STATE OF CONNECTICUT
CONNECTICUT SITING COUNCIL

SBA TOWERS III/NEW CINGULAR
WIRELESS PCS, LLC APPLICATION FOR A
CERTIFICATE OF ENVIRONMENTAL
COMPATIBILITY AND PUBLIC NEED
FOR A TELECOMMUNICATIONS FACILITY
LOCATED AT WEWAKA BROOK ROAD
BRIDGEWATER, CONNECTICUT

DOCKET NO. 412

SBA TOWERS III (“SBA”) AND NEW CINGULAR WIRELESS PCS, LLC (“AT&T”)
RESPONSES TO TOWN OF BRIDGEWATER INTEROGATORIES

ATTACHMENT 3

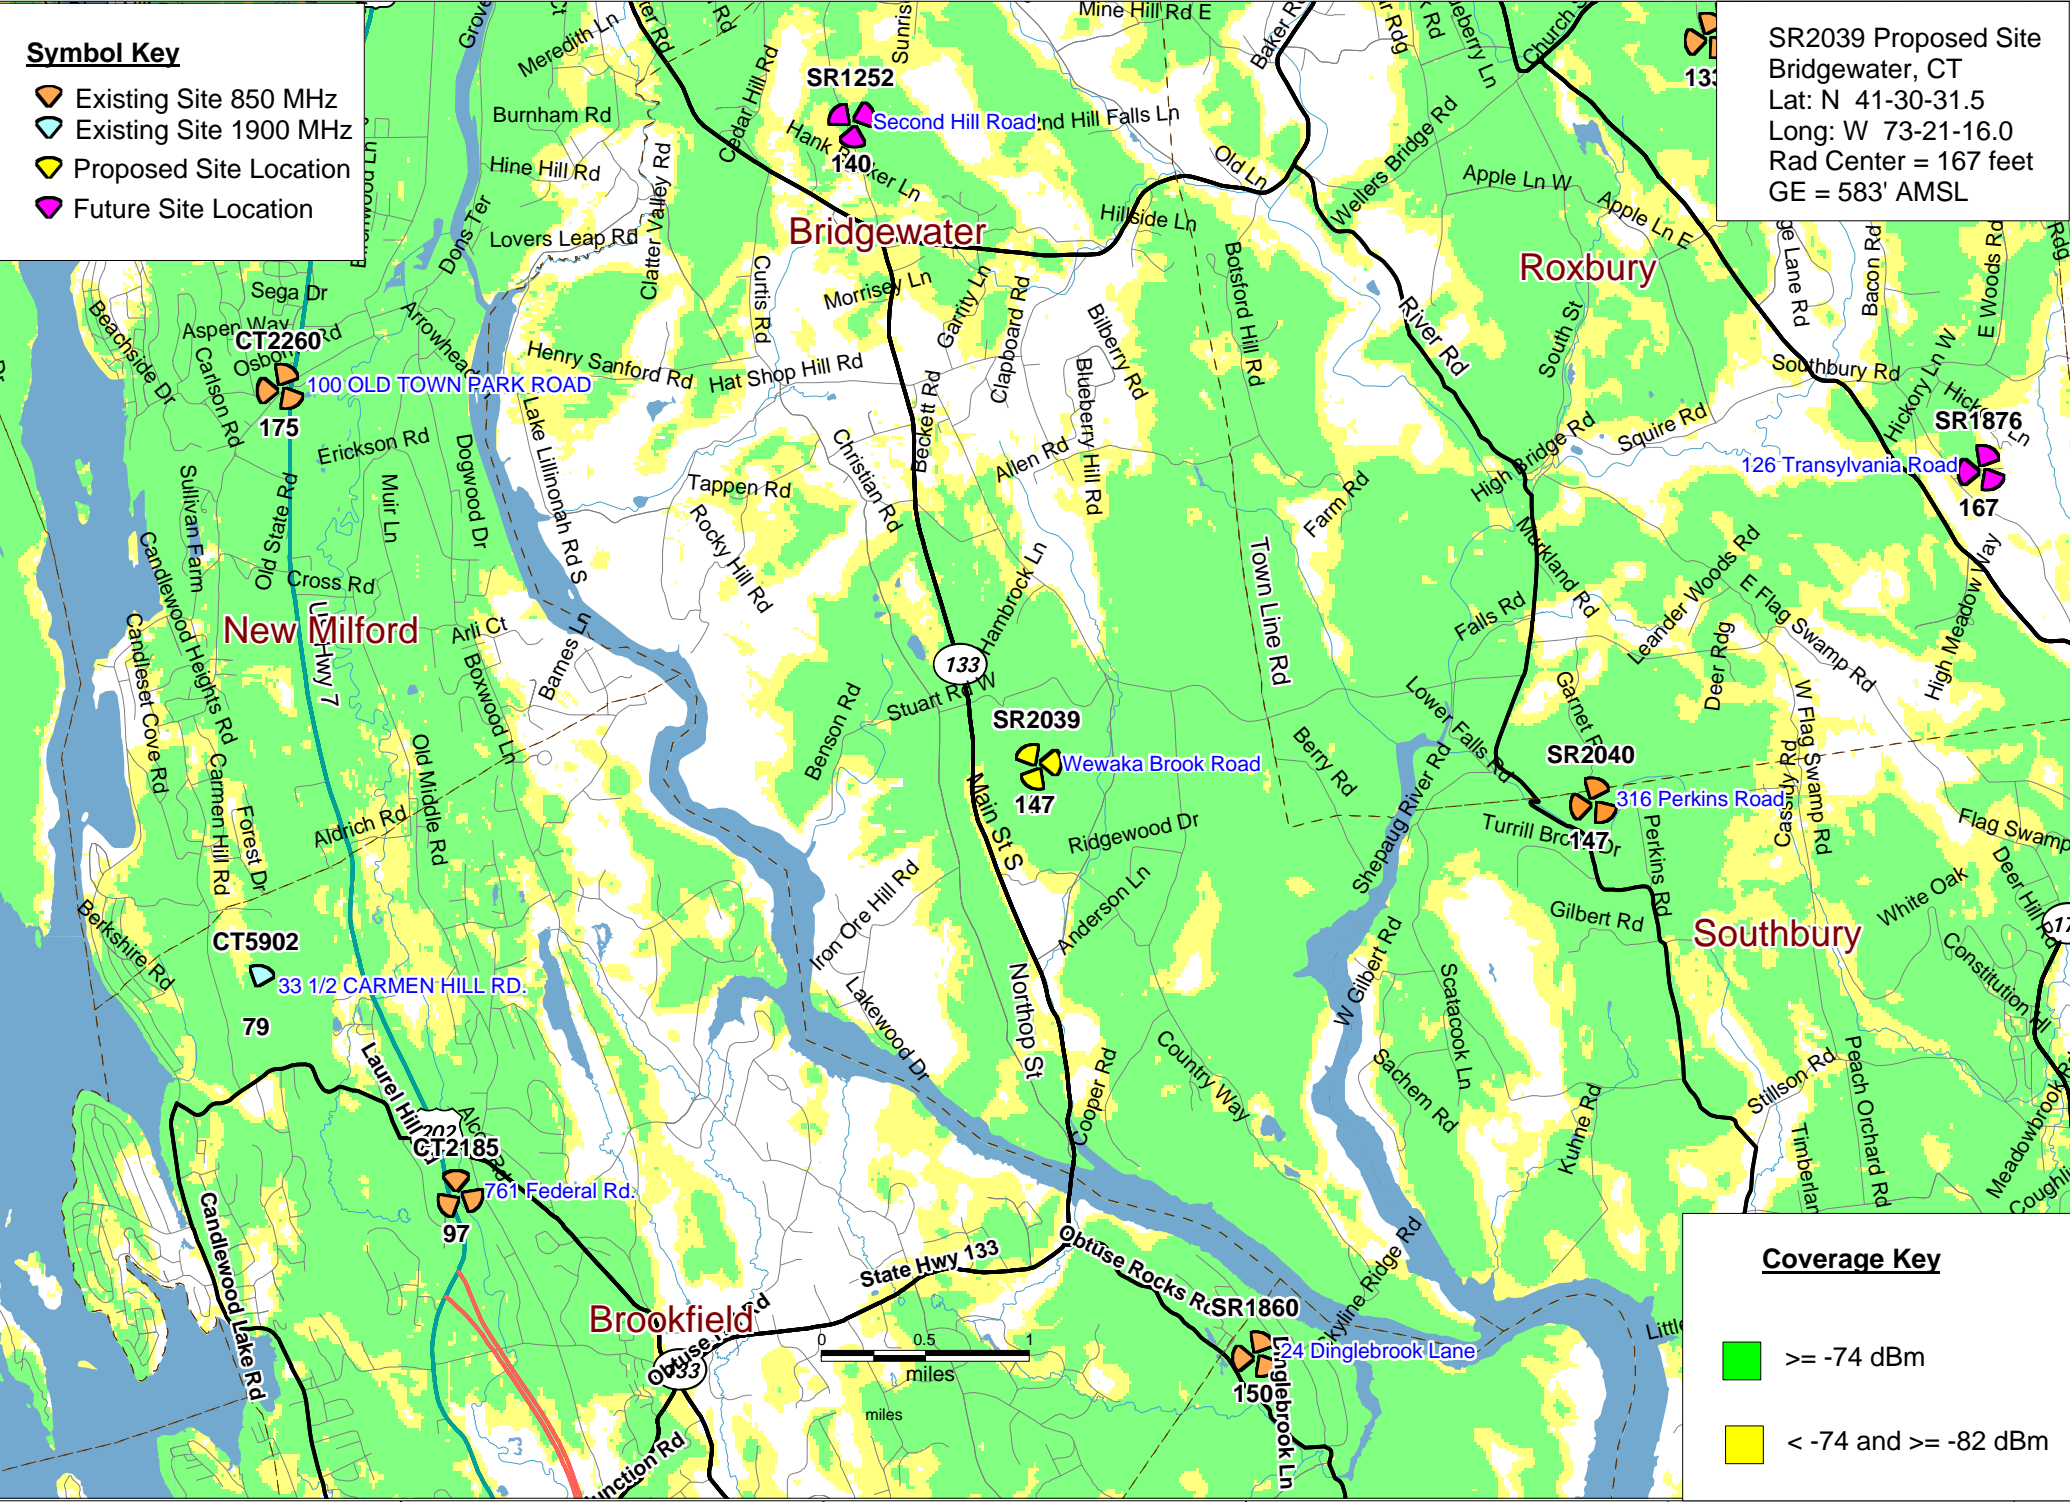
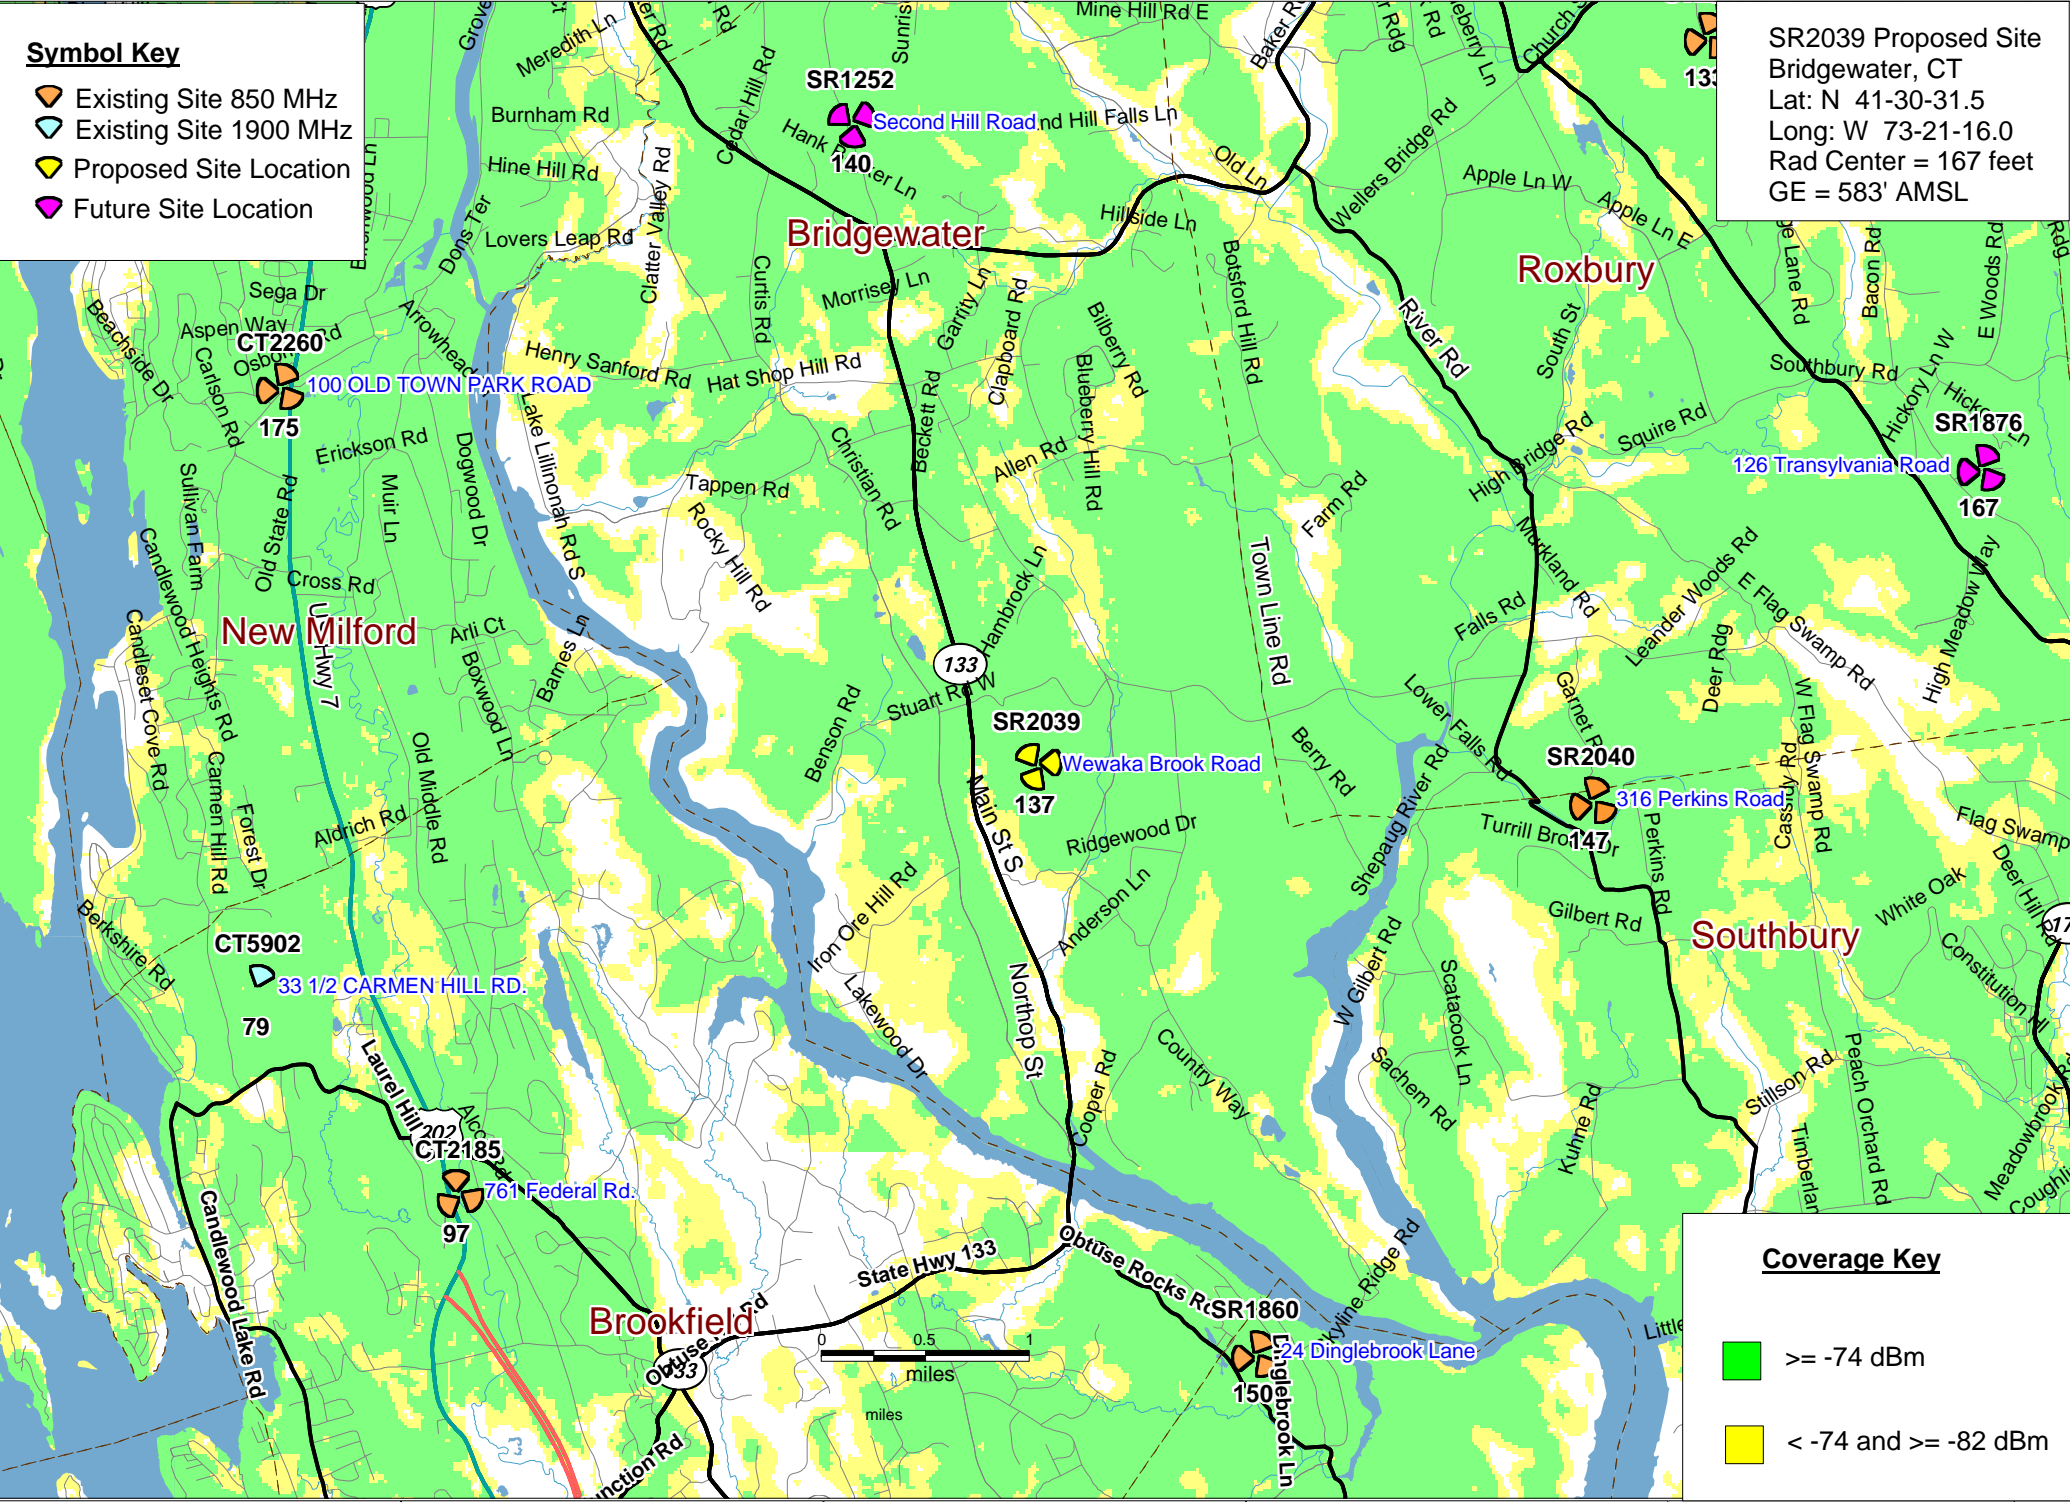
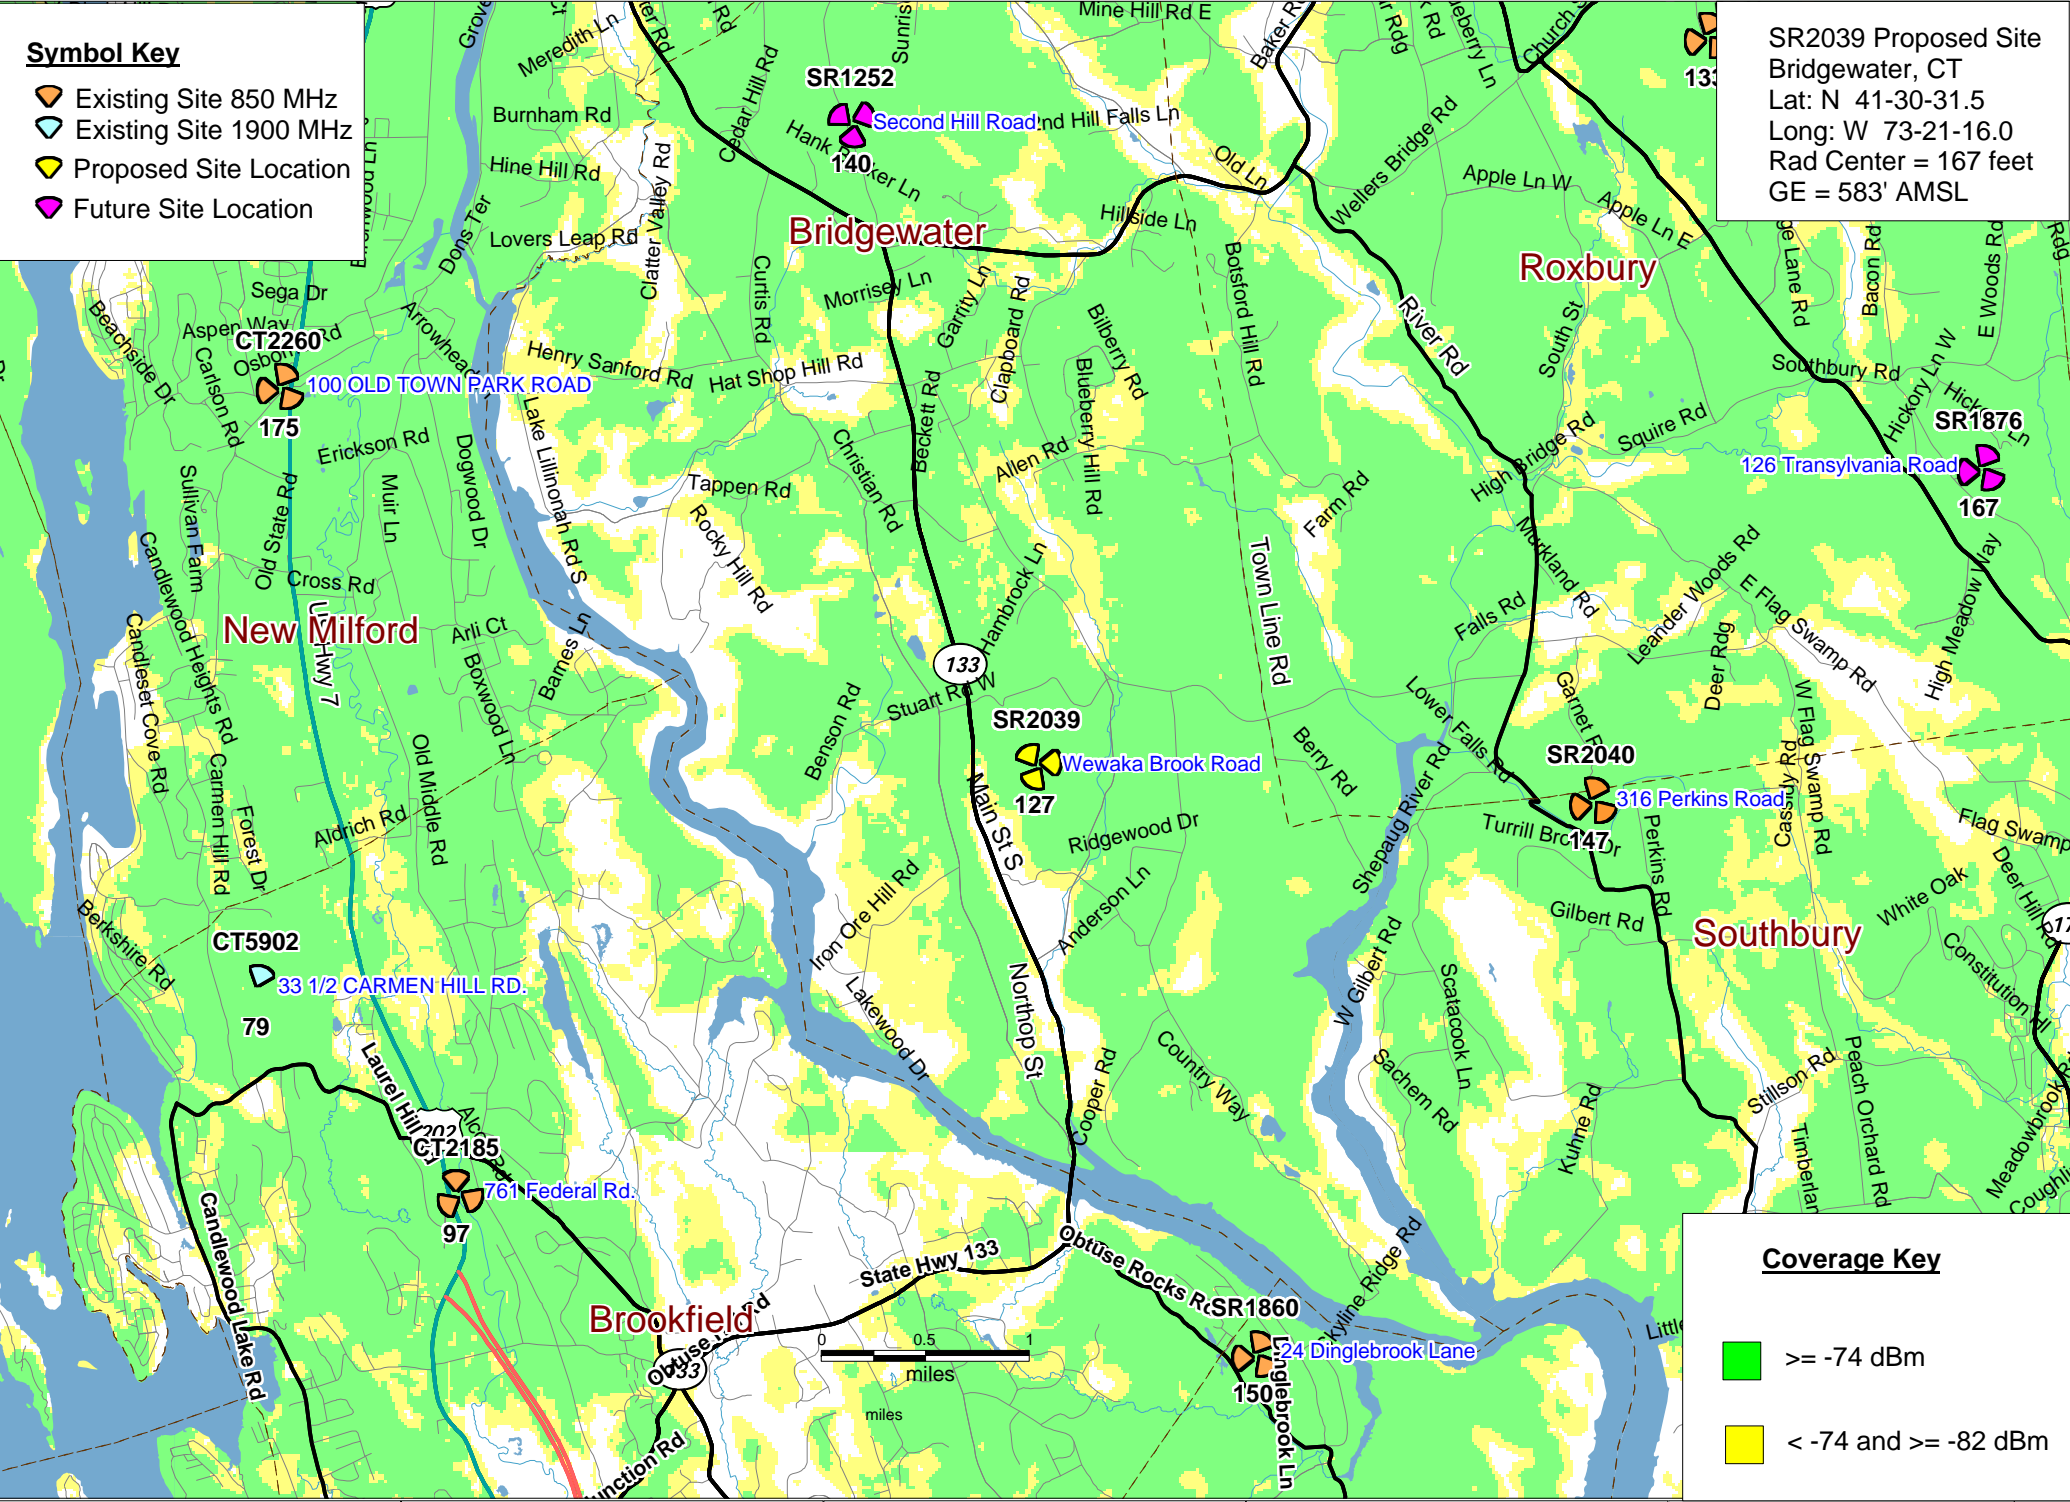
Q8. Has the applicant performed a minimum height analysis to determine the minimum antenna centerline that it requires to meet its alleged coverage needs?

Q37. Can you provide coverage propagation maps and isolated propagation maps for the proposed facility on clear plastic overlays using a scale that matches that of the application at heights 10 through 40 feet lower than that proposed?

A8. Yes. Please see plots included in Attachment 3 which depict coverage at lower heights.

A37. Plastic overlays showing the combined existing and proposed coverage with the proposed site at 10, 20, 30 and 40 feet below the requested height are being provided separately. Attachment 3 provides paper copies of same. Four (4) sets of overlays are being filed with the Siting Council as well.
